# Access Compliance Report

## Public Rights-of-Way

### (Curb Ramps)

Intersection ID: 50594	Main Street: BEAR_GRASS_LN	Cross Street: GRAY_WILLOW_RD	Location:	N
ADA ID: 498818989099	Ramp Type: Perp	Initial Pass/Fail: Fail	Overall Compliance: No	Severity Score: 10
Codes/Mitigation Info/Possible Solution		Field Measurements/Component Compliance

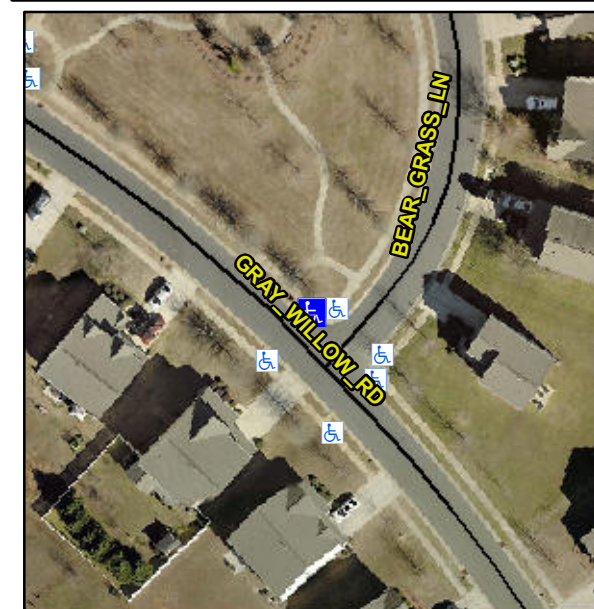
**Not Found, R304.5.1, R304.5.3**

Compliance	Description	Data	Compliance	Description	Data
N/A	Ramp Length (in)	53.0	Yes	Ramp Slope (%)	5.1
No	Ramp Width (in)	46.5	No	Ramp XSlope (%)	2.5
N/A	Flare Type LT	N/A	N/A	Flare Type RT	N/A
N/A	Flare Slope LT (%)	N/A	N/A	Flare Slope RT (%)	N/A
N/A	Flare Traversable LT?	N/A	N/A	Flare Traversable RT?	N/A
N/A	Landing Length (in)	N/A	N/A	DWS Provided?	N/A
N/A	Landing Width (in)	N/A	N/A	DWS Contrast?	N/A
N/A	Landing Slope (%)	N/A	N/A	DWS Length (in)	N/A
N/A	Landing X Slope (%)	N/A	N/A	DWS Full Width?	N/A
N/A	Landing Curb? (Y/N)	N/A	N/A	DWS Offset (in)	N/A
N/A	Shared Landing?	N/A			
N/A	Gutter Ponding?	N/A	N/A	Gutter Slope (%)	N/A
N/A	Gutter Lip Ht (in)	N/A	N/A	Gutter X Slope (%)	N/A
N/A	Painted X Walk1?	No	N/A	Painted X Walk2?	N/A
	X Walk 1 Direction	To SW		X Walk 2 Direction	N/A
N/A	X Walk 1 Width (in)	N/A	N/A	X Walk 2 Width (in)	N/A
	X Walk 1 Slope (%)	2.6		X Walk 2 Slope (%)	N/A
	X Walk 1 X Slope (%)	2.4		X Walk 2 X Slope (%)	N/A

**Remove & Replace Entire Ramp.**
